## PHEASANT BRANCH GREENWAY ENHANCEMENT

CITY PROJECT NO. 14370

ADDENDUM #2  
REVISED THE FOLLOWING:  
SHEETS D1-D3  
SHEETS EC1-EC4  
SHEETS G13, G15, G112  
SHEETS P1-P19, P21, P24-27  
SHEETS U1-U18, U22  
SHEETS E1-E6  
SHEET PM1  
SHEETS X32A-X34, X45-X48

14370  
 GRADING PLAN - GREENWAY  
 PHEASANT BRANCH GREENWAY ENHANCEMENT  
 MADISON, WI  
 CONTRACT NO.: 9517

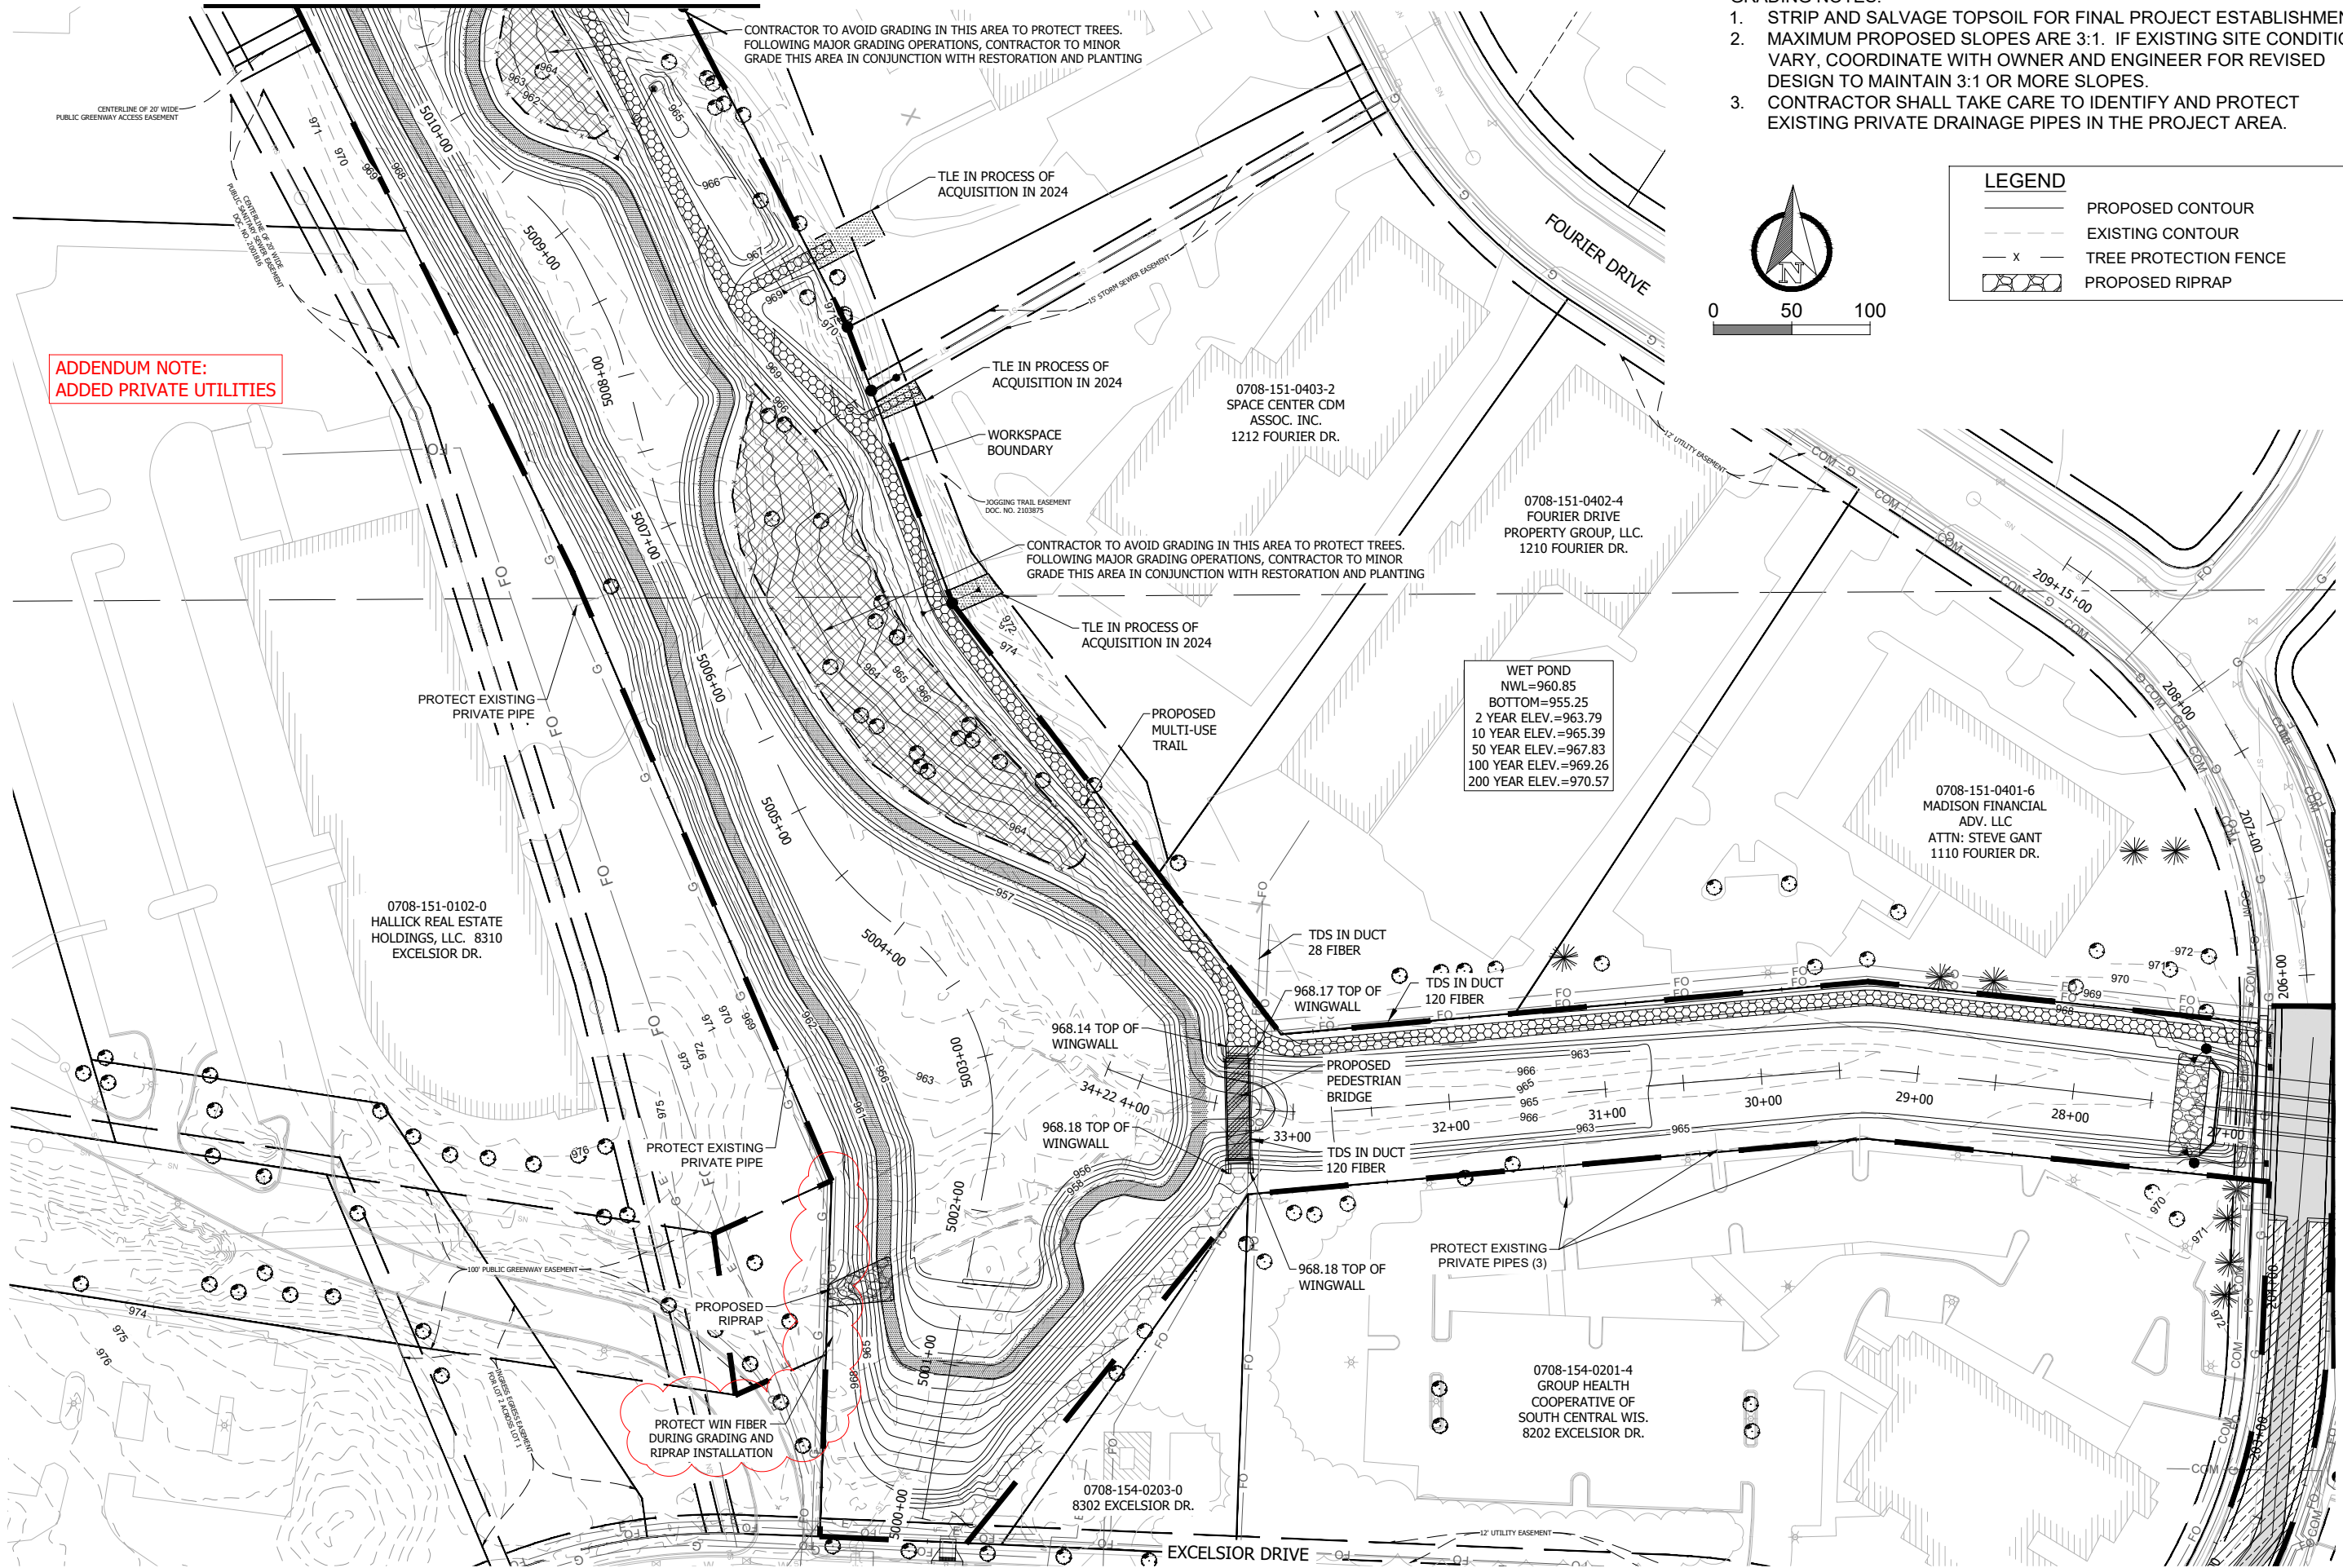
ADDENDUM NOTE:  
ADDED PRIVATE UTILITIES

14370  
P1

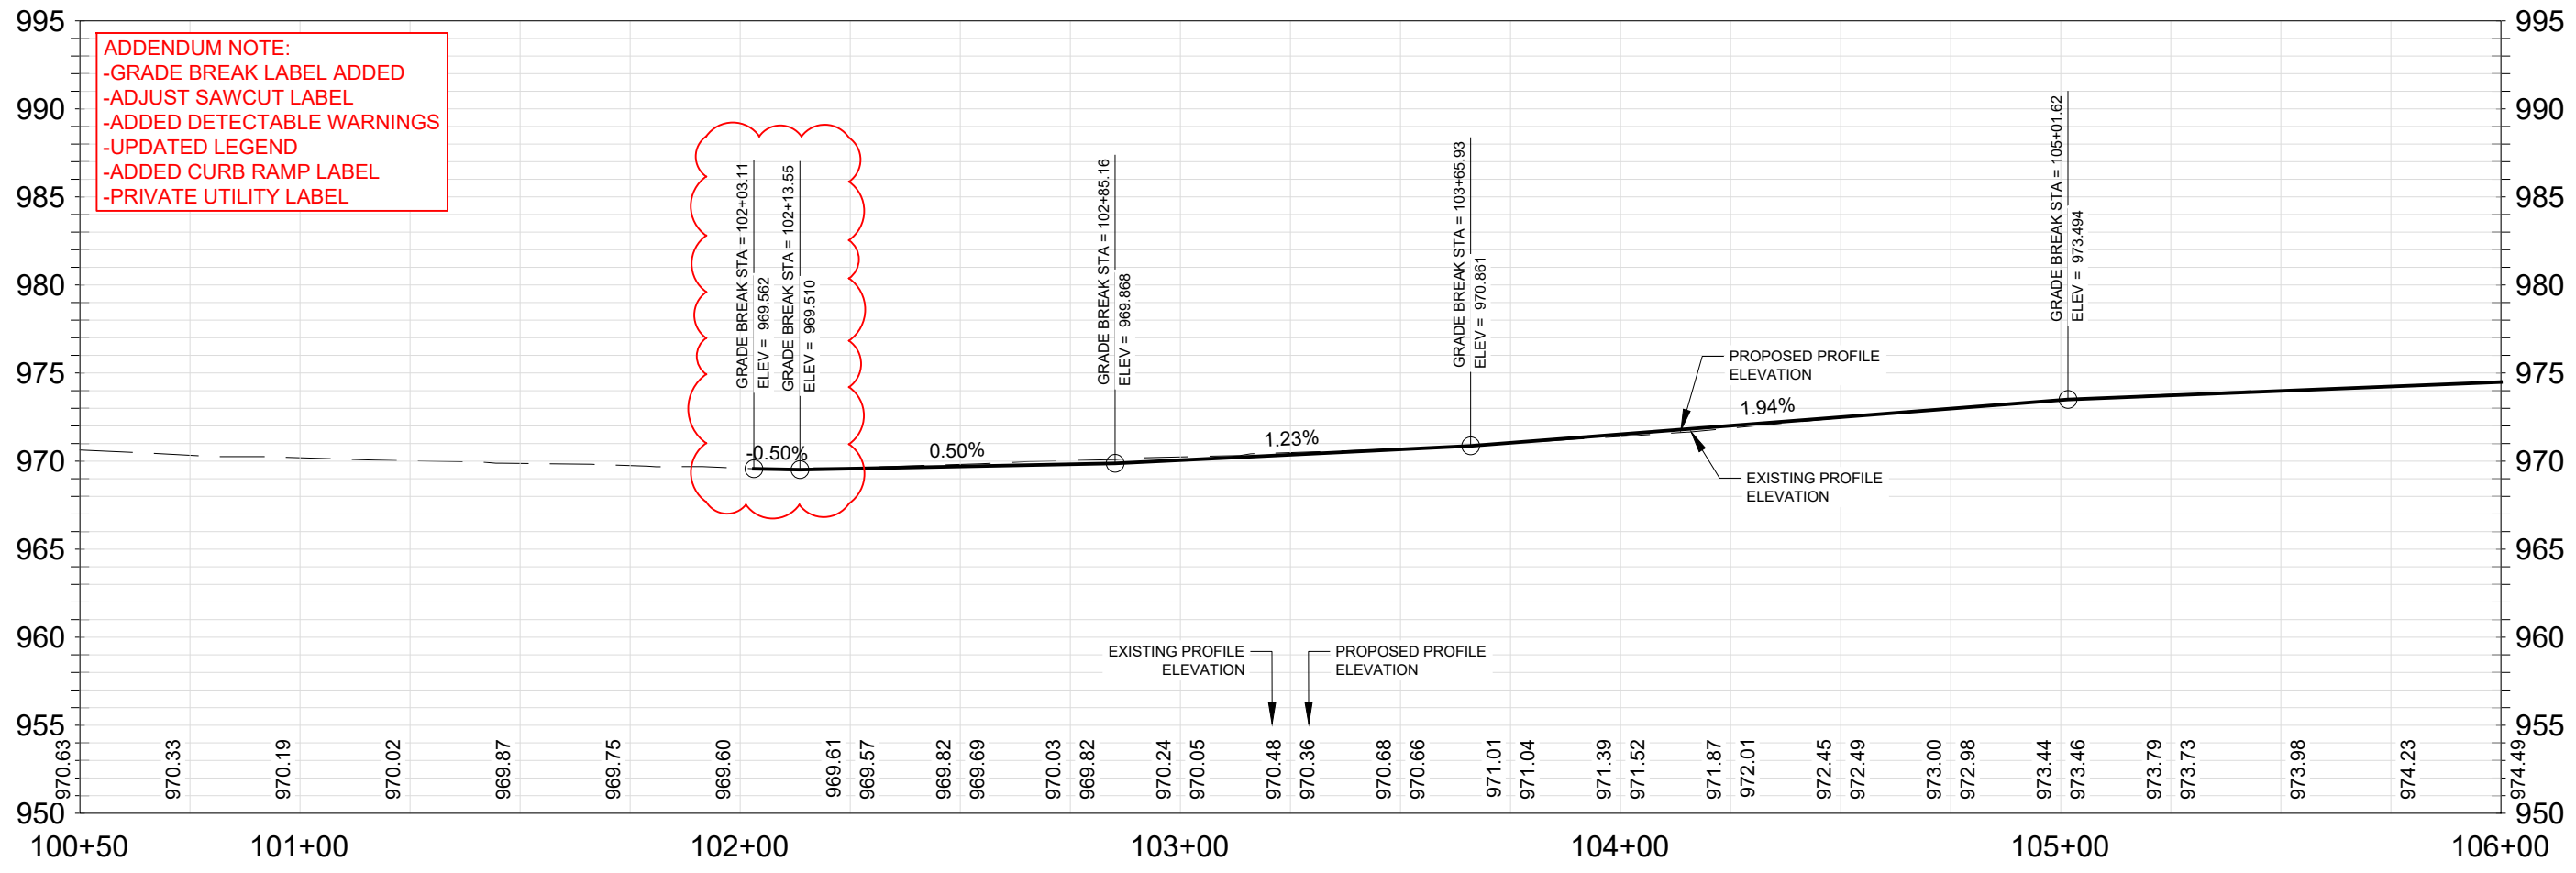
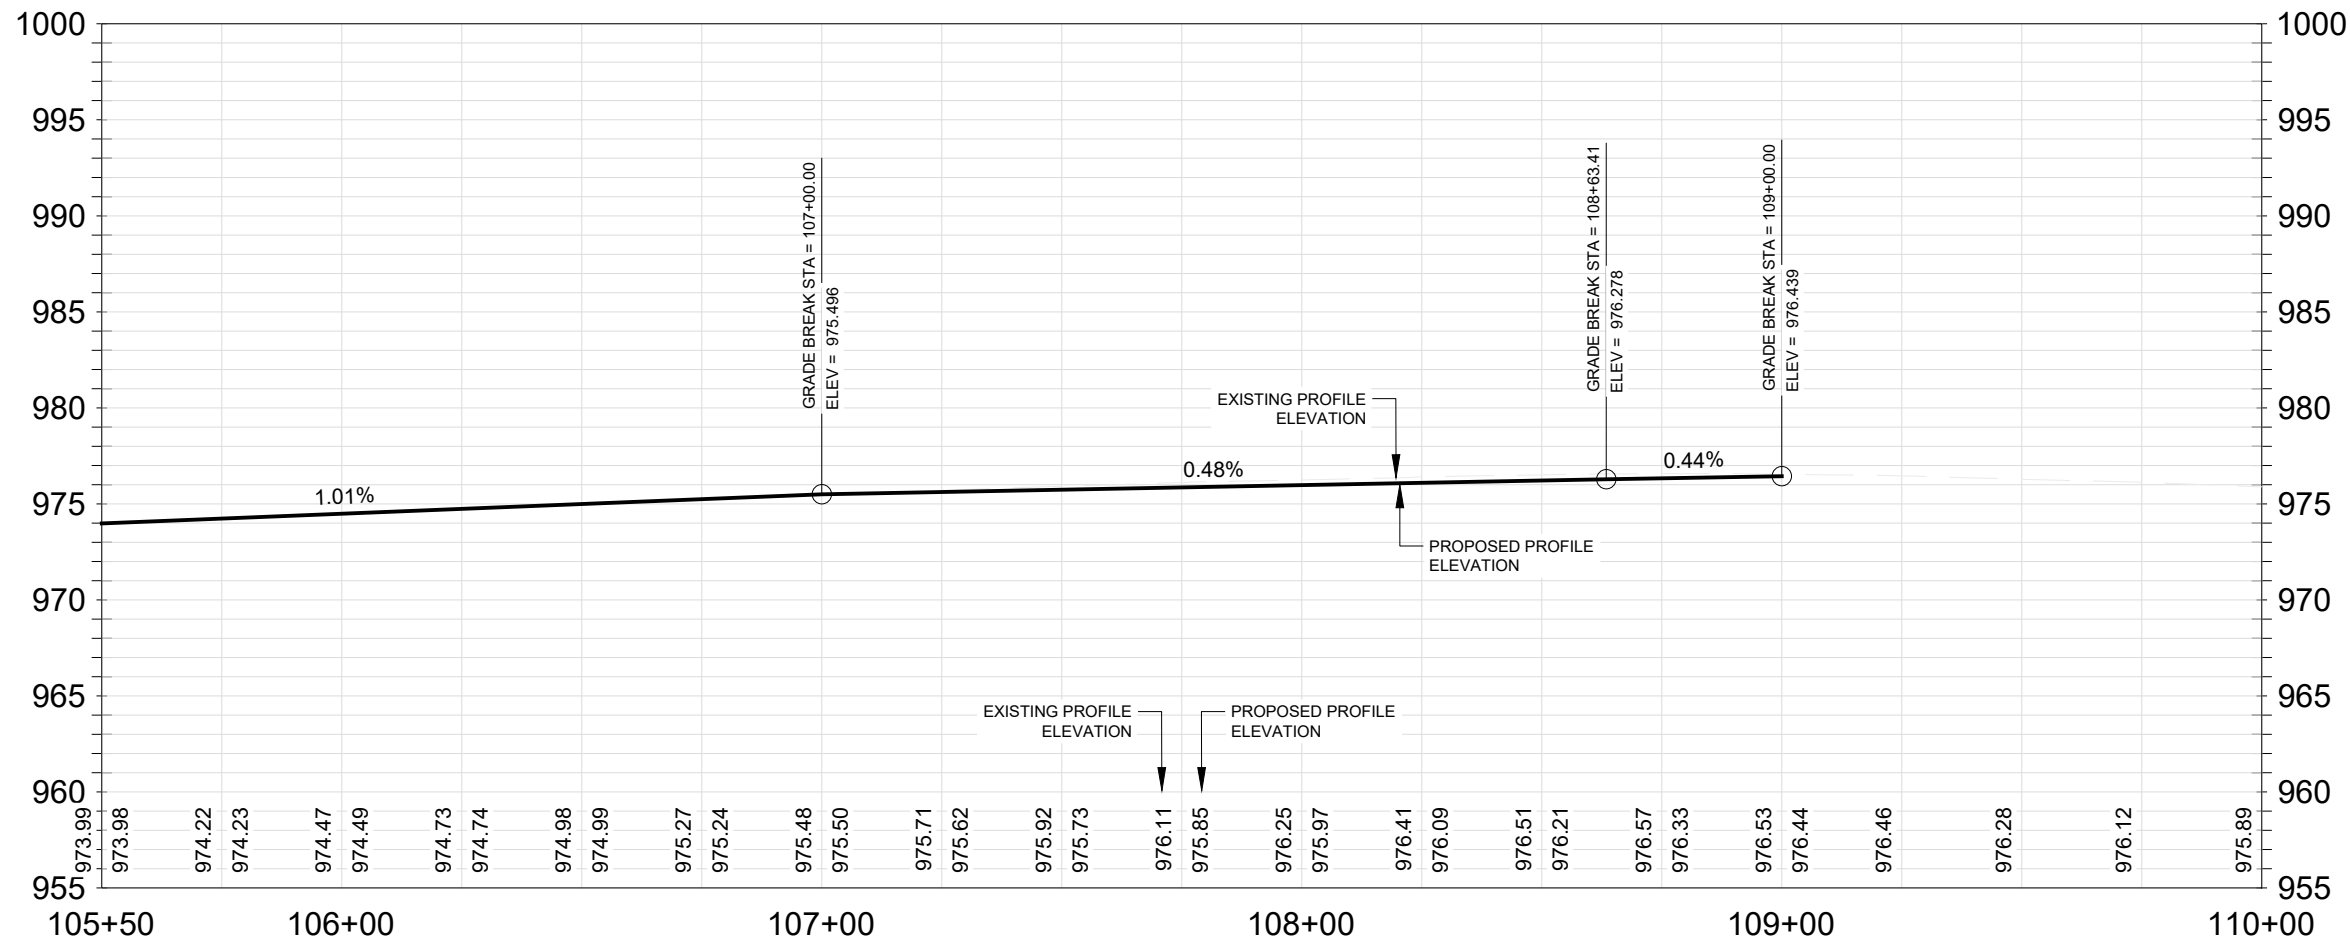
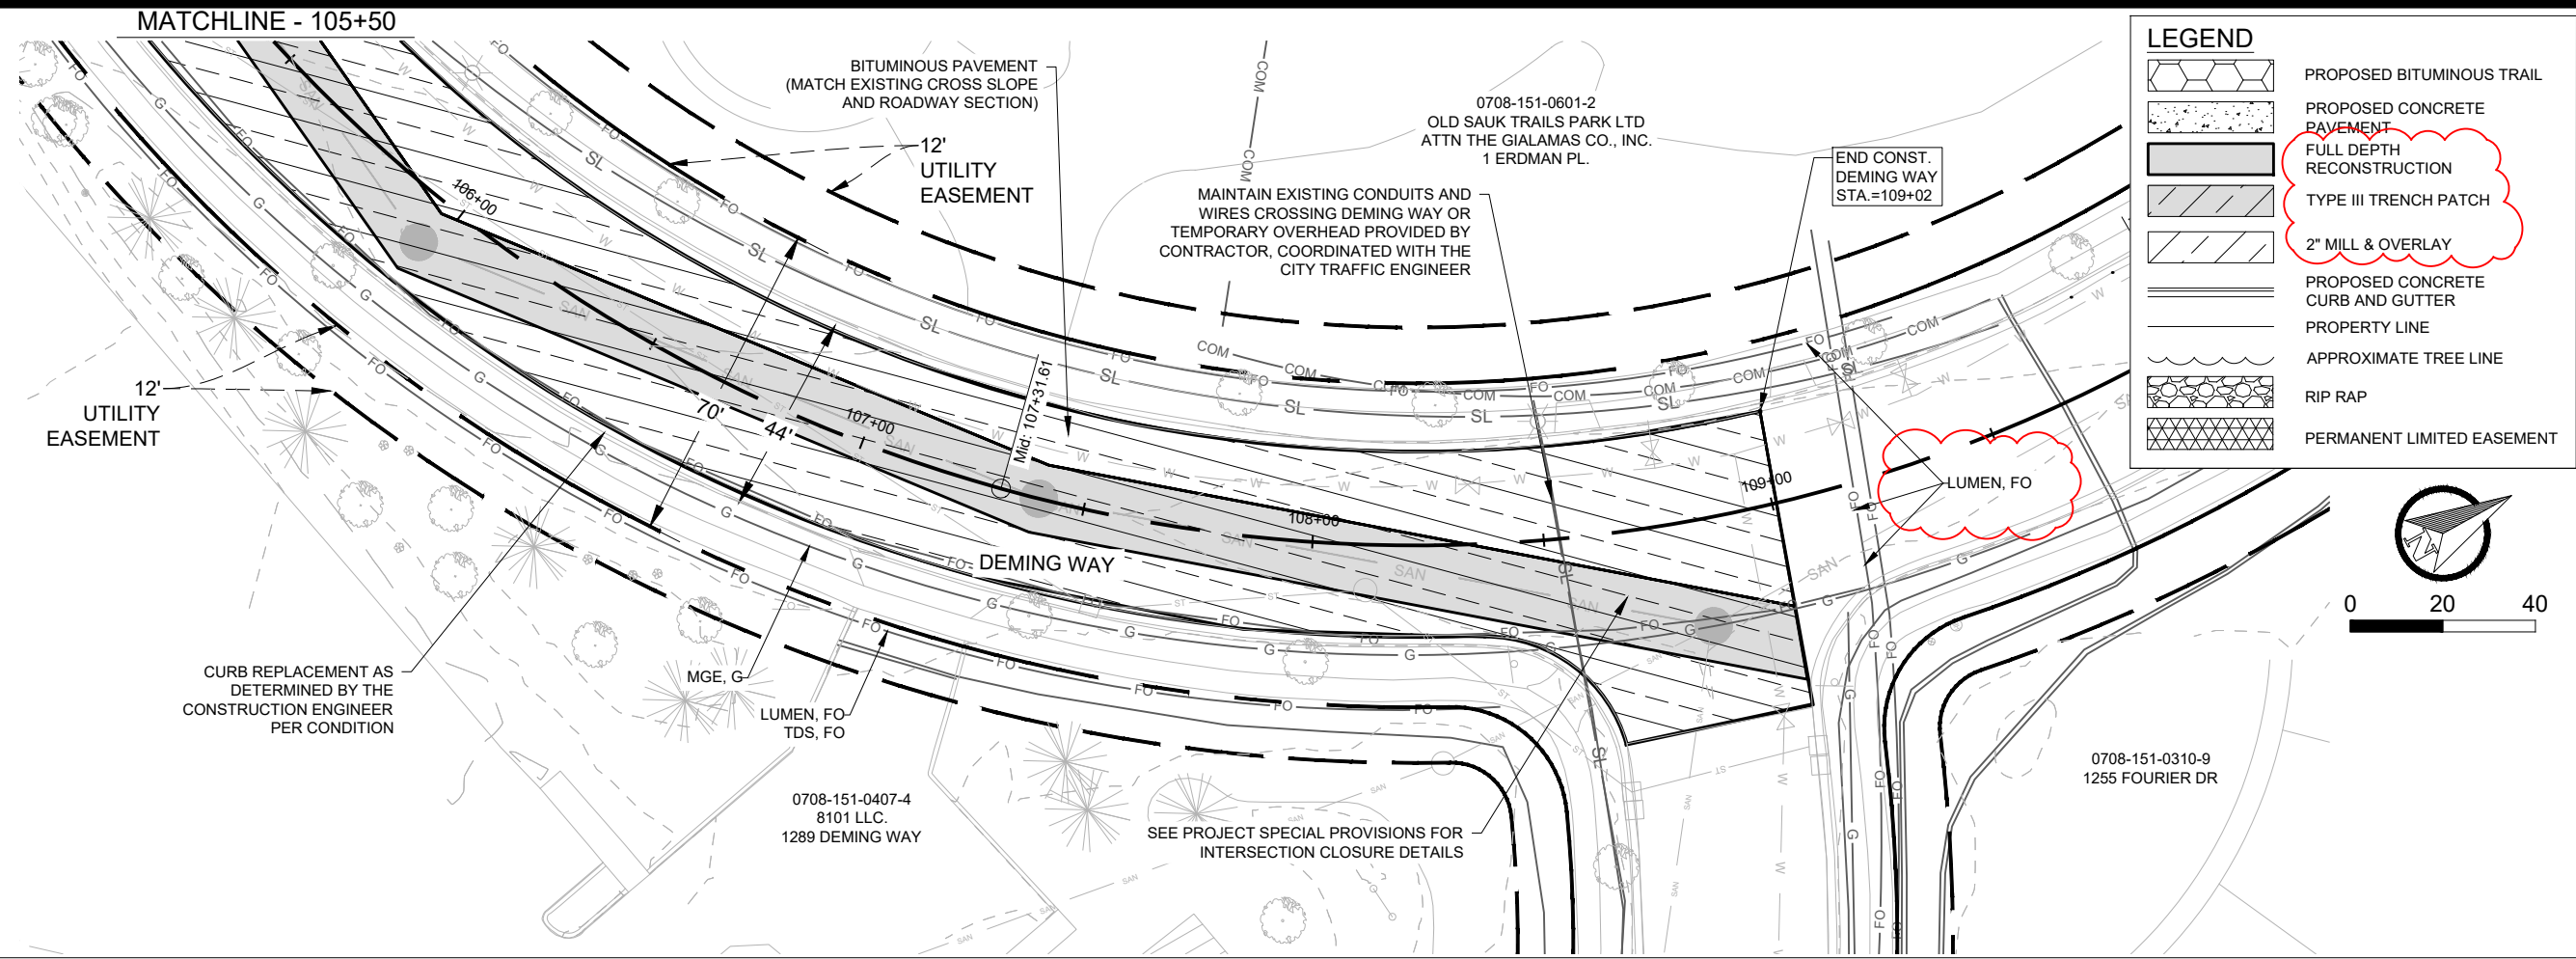
**ADDENDUM NOTE:**  
 -UPDATED LEGEND  
 -ADDED PRIVATE UTILITY NOTES
